NOV\_SCE\_ATJ\_ 20211116-01

# NOTICE OF VIOLATION

# Energy Safety Inspection Report

Report Name: ATJ\_SCE\_20211116

**Item10IA1mg1:** Vibration dampers not installed

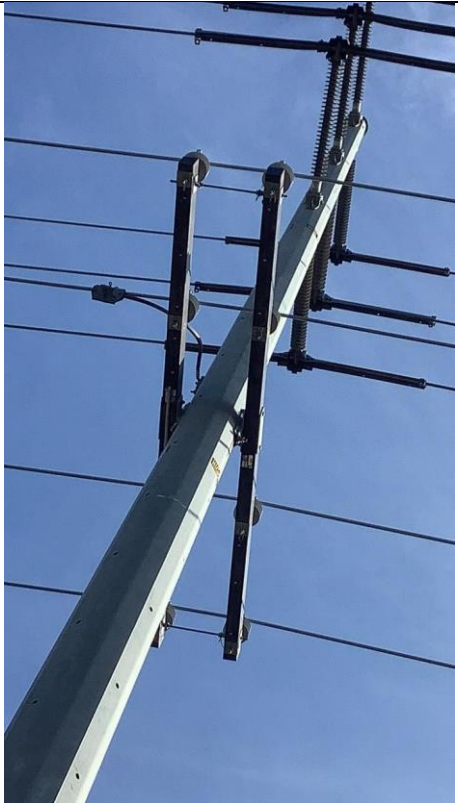
10	4476903E	Tier 3	7.3.3.3.1	Adherence to Protocol	Minor	Failure to install vibration dampers
11	4429437E	Tier 3	7.3.3.3.1	Adherence to Protocol	Minor	Failure to install vibration dampers
12	1922649E	Tier 3	7.3.3.3.1	Adherence to Protocol	Minor	Failure to install vibration dampers
